**MINOR VARIANCE APPLICATION
COMMENTS TO THE COMMITTEE OF ADJUSTMENT
PANEL 1**

Site Address: 339 Eastview Street
Legal Description: Lot 191, Registered Plan 238
File No.: D08-02-25/A-00265
Report Date: January 8, 2026
Hearing Date: January 14, 2026
Planner: Dylan Geldart
Official Plan Designation: Inner Urban Transect, Neighborhood Designation
Zoning: R4UA [1136]

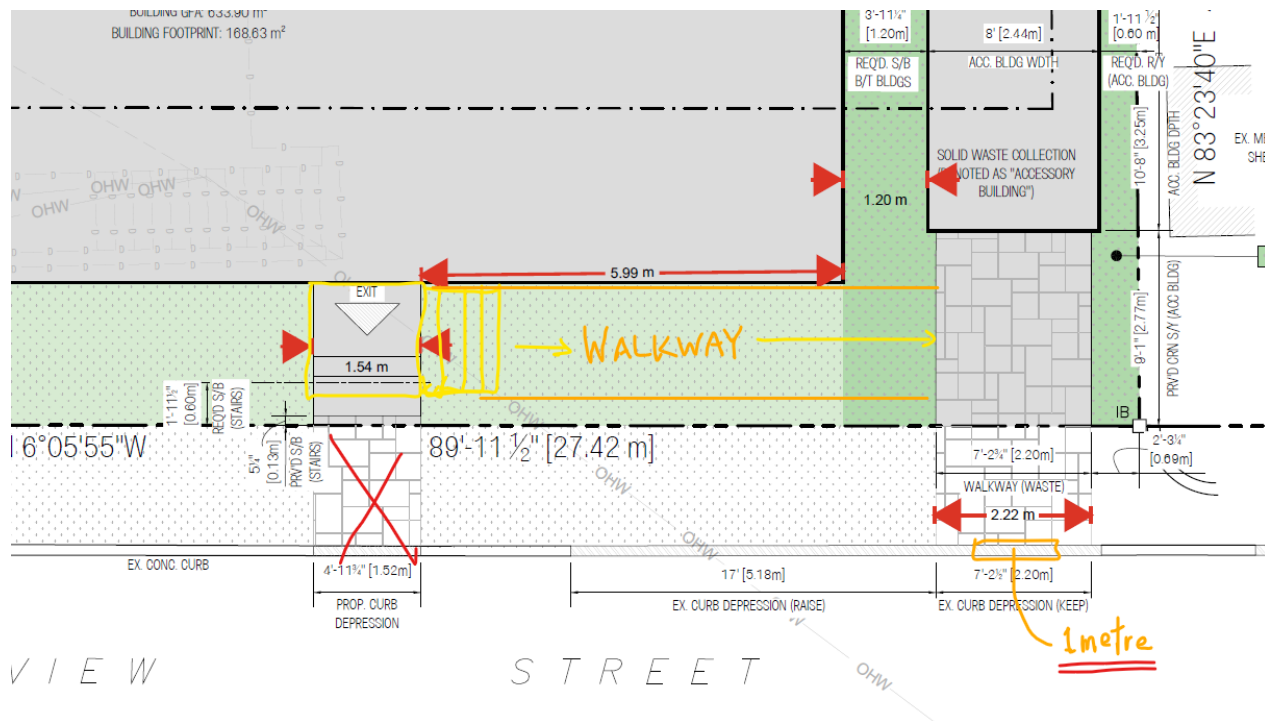
Comparing the conceptual 3D drawings and the site plan drawing, it doesn't look like the walkway and shed distance line up. Plus the walkway projecting out to Eastview from the main building is connecting to the solid waste collection building walkway which is not showing on the plans. If the main building walkway is connecting to the solid waste collection walkway, then it is not permitted to extend into the ROW. ROW proposes the entrance on Eastview to exit out on to a landing and the stairs extend down within the private property towards the solid waste walkway. See image.
